APPLICATION NO.	FILING DATE	FIRST NAMED INVENTOR	ATTORNEY DOCKET NO.	CONFIRMATION NO.
10/773,165	02/09/2004	Nobuya Nakagawa	248538US	6760

Office Action Summary

NAKAGAWA ET AL.

60-157914

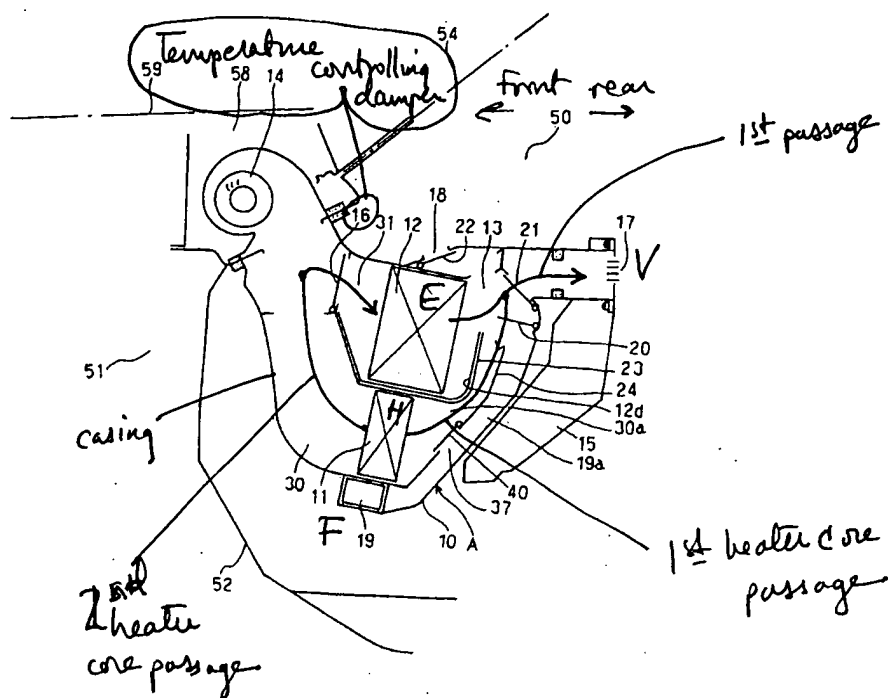
Claims 1 and 2 are rejected under 35 U.S.C. 102(b) as anticipated by or, in the alternative, under 35 U.S.C. 103(a) as obvious over JP 61-188214 or JP 60-157914.

See Figure 1 of JP '214 reproduced below, with the relevant limitations from claims 1 and 2 labeled. A similar Figure is also shown for JP'914.
